NET+50 Errata

Part number/version: 90000283_L
Release date: February 2006
www.digi.com

For use in conjunction with:
NET+50/20M Hardware Reference
Part number/version: 90000281_A
Release date: September 2002

This document contains information about NET+50 chip issues.

UART CTS-related transmit data errors

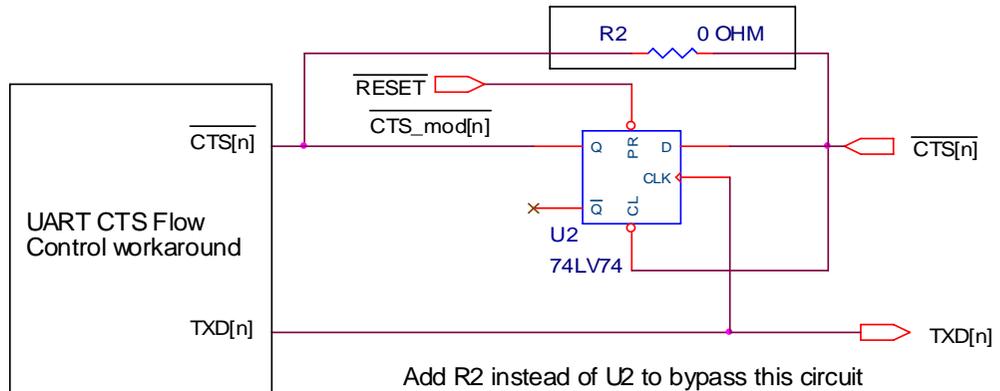
A problem occurs when the CTS flow control signal is de-asserted during the BCLK that begins processing a new character. This problem causes the previous character to be re-transmitted instead of getting the next character from the transmit FIFO.

- Modify these bits in Serial Channel Control register A:
 - Set the CTSTX bit (bit 23) to 0 to disable hardware-controlled CTSTX.
 - Set the ERXCTS bit (bit 4) to enable the software CTS signal change interrupt.
 - Update the serial transmit ISR to handle the CTS signal change.
- Non-DMA mode: Because FIFO can hold up to eight lines of 4 bytes each, the maximum skid rate will be 32 characters.
- To reduce the maximum skid rate to eight characters, the software is changed to write 1 byte in each line.
- In DMA mode, the skid rate can be up to the number of bytes transmitted in 1 tick.
- The serial monitor thread is changed to handle the missing CTS interrupt.

For each UART, externally clock the CTS signal with the Txd_n signal to guarantee that CTS will not be seen de-asserting at the start of a character.

Figure 2: 2-222 burst transfer

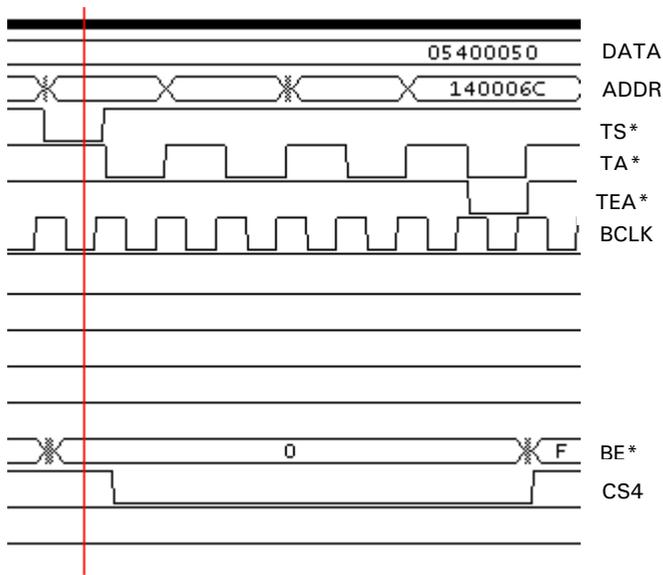
When a chip select is set as a synchronous read with the WAIT set to 0 and the BCYC field set to 00, the chip produces the correct 2-111 burst transfer:

An SRAM burst cycle transfer that occurs during a DMA transfer, however, will be a 2-222 burst transfer:

None.
